P.C. 09-19194

SUPERSEDES
NONE**-hp- MODEL 3570A NETWORK ANALYZER**

SIGN (+/-) ERRORS USING HP-IB

Figure 1. Circuit Before Change.

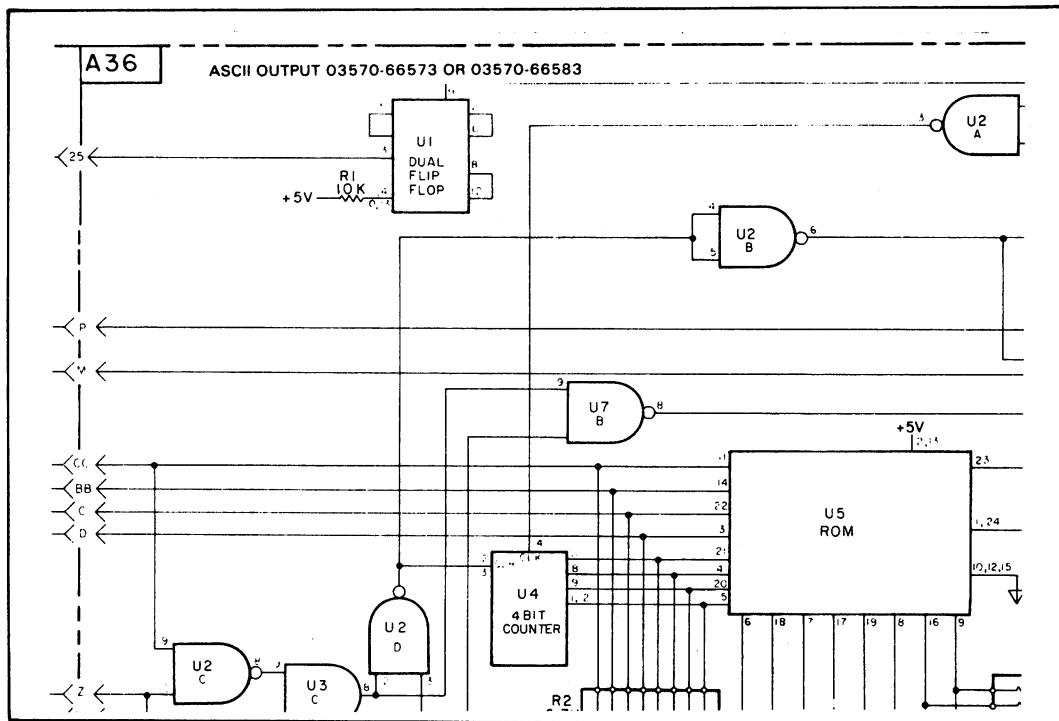
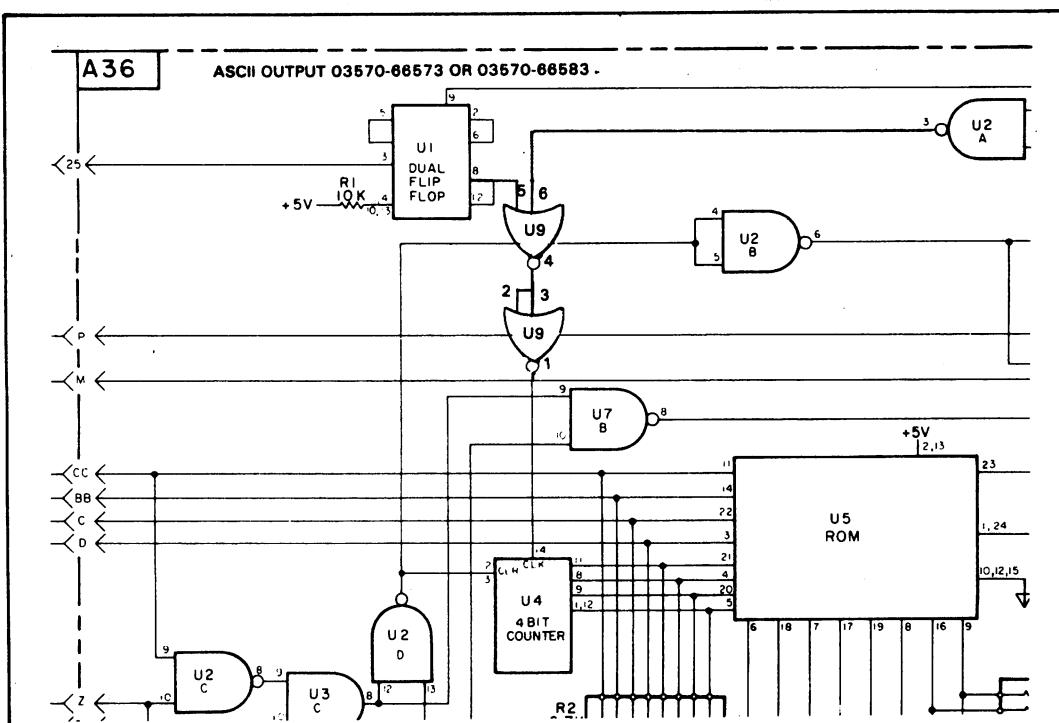
A change has been made on the ASCII output board, A36, that eliminates +/− sign errors which occasionally occurred when using the 3570A on the HP-IB.

When a 3570A is used on the HP-IB, particularly with an -hp- 9825 Calculator, sometimes the 3570A reading will come up positive on the calculator when it was actually negative. This occurs because of a timing problem with the synchronous and asynchronous operations on the A36 board. The timing problem causes a counter that is used to "look up" the ASCII characters to be transmitted over the HP-IB, to omit sending the "sign" character. Thus by default the 3570A output will occasionally be interpreted as positive when it was actually negative.

If you see this problem, a minor change in the clocking technique will eliminate it. Figure 1 shows the previous circuit configuration while Figure 2 shows the change that should be made. The NOR gates on U9 were previously unused. These new connections should be hardwired on the circuit (non-component) side of A36. Do not forget to break the trace that goes directly from U2 to U4. Also note that A36 was changed from 03570-66573 to 03570-66583, however, this modification can be made on either of these boards.
